ORIGINATION FORM

Proposed Revisions to a Standard Plans Index

Index Number: 400-010

Index Title: Cantilever Retaining Wall (C-I-P)

TYPICAL BACKFILL DETAIL

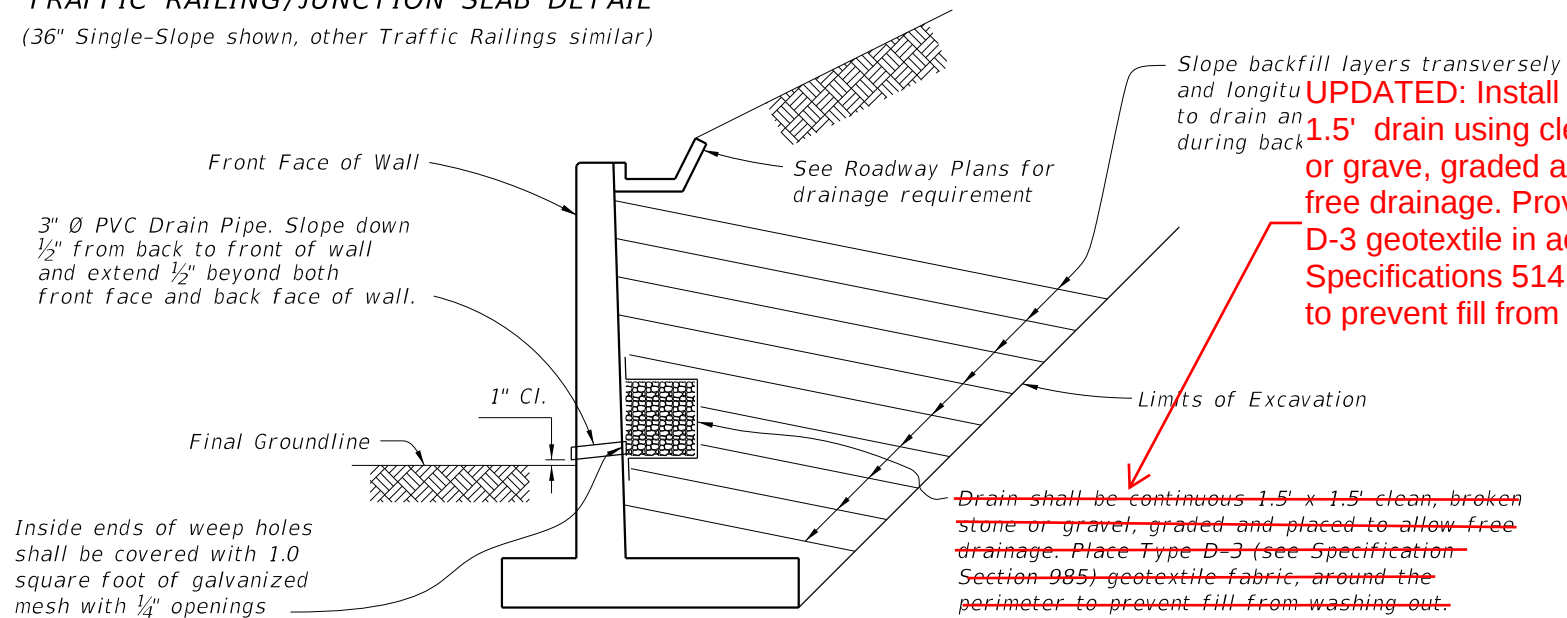
Sheet 2: Updated the TYPICAL BACK-FILL DETAIL Callout: " Install a continuous 1.5' x 1.5' drain using clean, broken stone or grave, graded and placed to allow free drainage. Provide and install Type D-3 geotextile in accordance with Specifications 514 around th perimeter to prevent fill from washing out."

SECTION A-A
EXPANSION JOINT DETAIL

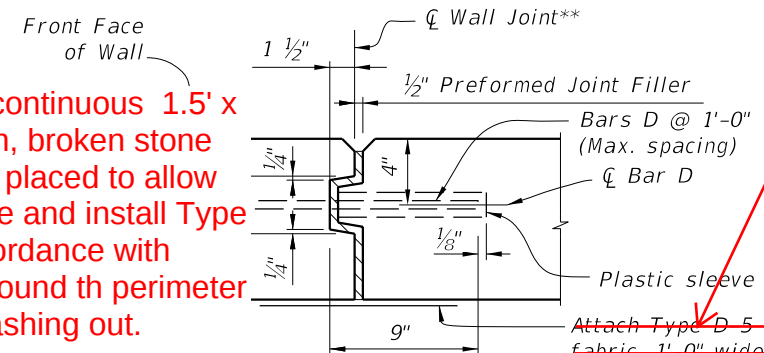
Updated the EXPANSION JOIND DETAIL (SECTION A-A) Callout: "Provide and install Type D-5 geotextile in accordance with Specifications 514. Attach geotextile, 1'-0" wide and full height to fill, to the back of wall with an adhesive approved by the Engineer."

UPDATED; Provide and install Type D-5 geotextile in accordance with Specifications 514. Attach geotextile, 1'-0" wide and full height to fill, to the back of wall with an adhesive approved by the Engineer
